Access Compliance Report

Public Rights-of-Way

(Curb Ramps)

Intersection ID: 14633	Main Street: E_KINGSTON_AV	Cross Street: PARK_RD	Location:	N
ADA ID: 797FDADB27CD	Ramp Type: Perp	Initial Pass/Fail: Fail	Overall Compliance: No	Severity Score: 26.25

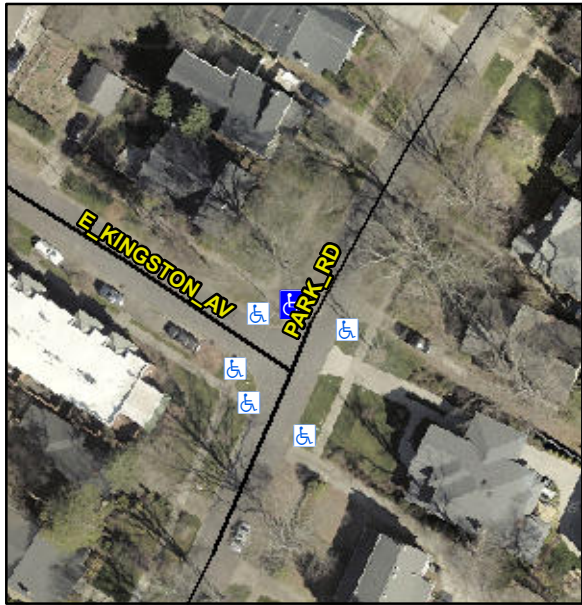
Codes/Mitigation Info/Possible Solution			Field Measurements/Component Compliance							
	Possible Solutions:		Compliance			Description			Data	
	Remove & Replace Entire Ramp.		N/A	Ramp Length (in)	149.0	No	Ramp Slope (%)	15.2		
			Yes	Ramp Width (in)	48.0	Yes	Ramp XSlope (%)	3.9		
			N/A	Flare Type LT	N/A	N/A	Flare Type RT	N/A		
			N/A	Flare Slope LT (%)	N/A	N/A	Flare Slope RT (%)	N/A		
			N/A	Flare Traversable LT?	N/A	N/A	Flare Traversable RT?	N/A		
			N/A	Landing Length (in)	N/A	N/A	DWS Provided?	N/A		
			N/A	Landing Width (in)	N/A	N/A	DWS Contrast?	N/A		
			N/A	Landing Slope (%)	N/A	N/A	DWS Length (in)	N/A		
			N/A	Landing X Slope (%)	N/A	N/A	DWS Full Width?	N/A		
Surveyor Notes:		N/A	N/A	Landing Curb? (Y/N)	N/A	N/A	DWS Offset (in)	N/A		
PROW/ADA:		Not Found, R304.2.2	N/A	Shared Landing?	N/A					
			N/A	Gutter Ponding?	N/A	N/A	Gutter Slope (%)	N/A		
			N/A	Gutter Lip Ht (in)	N/A	N/A	Gutter X Slope (%)	N/A

N/A	Painted X Walk1?	No	N/A	Painted X Walk2?	N/A		
				X Walk 1 Direction	To SE		X Walk 2 Direction	N/A		
			N/A	X Walk 1 Width (in)	N/A	N/A	X Walk 2 Width (in)	N/A		
				X Walk 1 Slope (%)	4.1		X Walk 2 Slope (%)	N/A		
				X Walk 1 X Slope (%)	4.9		X Walk 2 X Slope (%)	N/A		
			N/A	Ramp inside XWalk1?	N/A	N/A	Ramp inside XWalk2?	N/A		
				Road Slope (%)	N/A	N/A	Clear Space?	N/A		
				Road X Slope (%)	N/A	N/A	Clear Space to XWalk (in)	N/A		
			N/A	Any Obstructions?	N/A	N/A	Storm Grate/Utility Hazard?	N/A		
				Obstruction Type			Storm Grate/Utility Type			
						N/A		N/A		
						Yes	Surface Condition? (G/P)	Good		
Total Cost:		\$ 1850.00
